LOT 100
HUNTINGFIELD DESIGN REVIEW

HUNTINGFIELD DESIGN REVIEW

29/05/26

This advice relates to the current revision DAS-2020-26/D.

Figure 3: Floor Plan (buildwise, 2026)

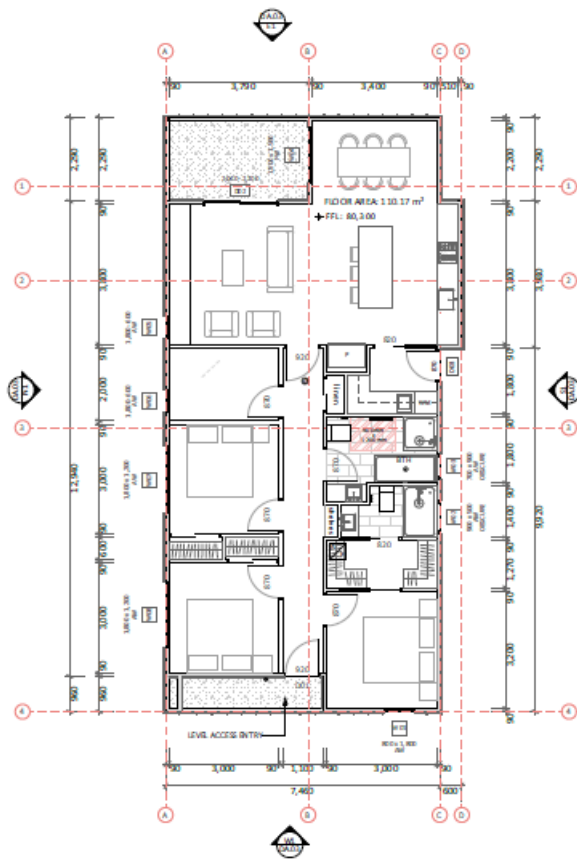
The proposal is wholly contained within the building envelope, aside from a small protrusion along the Southern boundary. As this is less than 9m in length, it is still able to comply with the acceptable solutions.

a) Site coverage refers to the proportion of a site that is covered by roofed structures. The lot has an area of 367m², with a roofed area of approximately 125m², representing 34% site coverage.

The POS as indicated on the plans is able to satisfy the above as it is 24m² in size, with a 4m width, and has a gradient no more than 1 in 10, and is oriented north.

iv) No corner glazing is proposed. Glazing units are separated by solid wall returns. No direct window-to-window sightlines occur through the building. Accordingly, the design satisfies (b)(iv).

1.2	AS	<input type="checkbox"/>	Design is rated 7-star NatHERS or higher (verified by an accredited assessor)		
	PC	<input checked="" type="checkbox"/>	Insulation between bedrooms and parking areas, primary living spaces and the front doors of adjoining dwellings are specified in accordance with best practice advice provided by the ABCB	P. Able to comply - more detail required to confirm compliance.	
		<input checked="" type="checkbox"/>	Design includes external shading for north and west facing windows	P. The floor plan and elevations indicate some protection through roof overhangs and the alfresco area. There is also a window box around west facing window. However, there are no dedicated external shading devices such as

awnings, pergolas, blades or screens specifically addressing northern facing glazing. Confirmation from homes tas is required as to whether the awning is sufficient shading provided.	
		<input checked="" type="checkbox"/>	Solar heat gain from north and west facing windows is controlled	P. awning is provided but confirmation by homes tas is required if this is suitable amount of shading provided.	
		<input checked="" type="checkbox"/>	Bedroom windows and any windows facing the street are double glazed	P. more details required.

Mandatory actions for lodgement	Preferable actions for lodgement
HUNTINGFIELD DESIGN GUIDELINES	Where a 7-star NatHERS or higher rating is not achieved, include notations on the plans for insulation between bedrooms, parking areas, and living spaces.	Ensure design is rated 7-star NatHERS or higher (verified by an accredited assessor). Where this cannot be achieved, ensure insulation, shading and glazing are provided to the relevant standards.
	Include notations on the plans to show thermal performance, durability and ability to be maintained overtime.	
	Include notation for double glazing, particularly for street facing windows.	Provide a window glazing schedule where possible
	Eaves are provided over the northern/western side of the dwelling but confirmation by homes Tasmania is required if this is a suitable amount of shading provided to north / west windows.
